A ground-floor shower · design review G-07, ageing in place · three positions compared · Taif / Palm House V8.1 · STUDY ONLY

2 Nov 2026 · today the ground floor has the family WC, the guest WC and the maid bath (the only shower, the maid's) · a level walk-in shower ≥ 0.9 × 1.2 m, a 1.5 m turning circle where possible, access from the family side, a drain to a stack, ventilation, privacy · nothing in the design files changes until the owner decides · all sizes assumed

P1 · the family WC and the family basins become one accessible wet room (recommended)

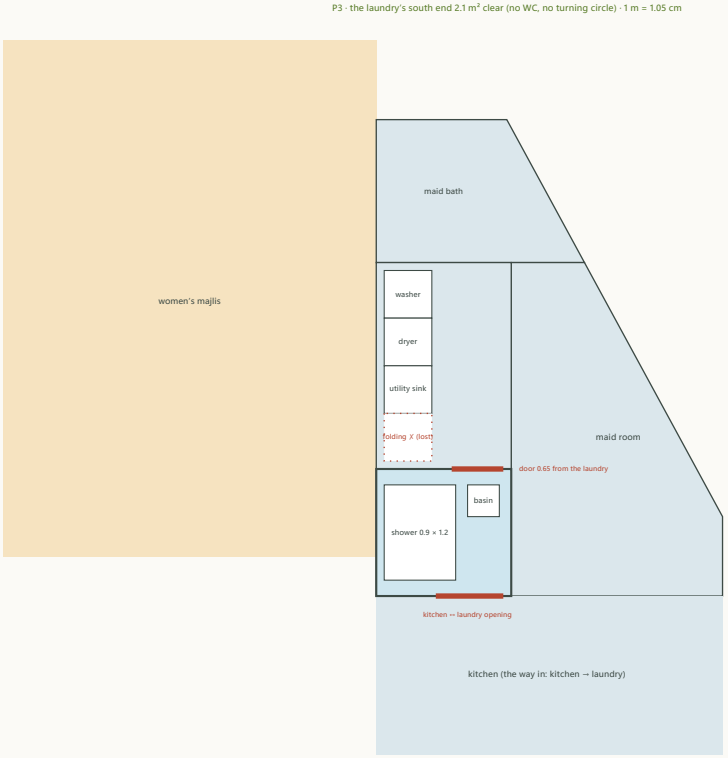
- **Where:** the west wash block, x 0–2.75, y 12.9–16.1: the two rooms merged by removing the wall on y 14.4; **2.53 × 3 = 7.57 m² clear**.
- **Layout:** the **wudu basin counter kept** on the north wall (two basins, 1.2 m); a **level walk-in shower 1.2 × 1.2** at the south-west corner (a fold-down seat, grab rails, a curtain or a half screen, the floor falling to its outlet: the ground slab is on grade, so the floor is lowered locally with no beam in the way); the **WC** at the south-east corner with grab rails both sides; a **1.5 m turning circle** in the middle (the level shower zone may be part of it); a **1.0 m sliding door** on the riwaq side (no swing in the 1.30 m riwaq), parking on the 1.9 m of wall south of it. Non-slip tiles, a hand shower, lever taps, a night light.

- **Access:** from the riwaq (the family side), 3 m from the lift, never through the guest side. **Drain:** the shower outlet into the west drain run under the wash block beside the existing WC stack (one run, as decided). **Ventilation:** a small west window (sill +1.8, under the first-floor bath 3's window) plus an extract fan. **Privacy:** its own door; the shower and the WC at the south end, out of the door's sight line; the basins by the door.

- **Effect on the rooms around:** the **open wudu basins** (open to the riwaq today) are now **behind a sliding door that stays open by day**: the one real loss; the hospitality kitchen, the serving passage, the utility room and the riwaq are untouched. **Structure:** the GF wall on y 14.4 carries the hidden beam **B14** under the first-floor wall between bedroom 2 and bath 3: without the wall, B14 becomes a **drop beam 0.25 × 0.45** spanning 2.75 m from the west wall to B10, hidden in the wet room's gypsum ceiling (the house rule): the engineer.

- **Conditions for P1:** the engineer confirms B14 as a drop beam (or a lintel) over the removed wall; the MEP engineer the floor drain's fall in the ground slab and the fan; a lever-handle sliding door; the wet room finished to the ageing-in-place list (seat, rails, non-slip floor, a night light).
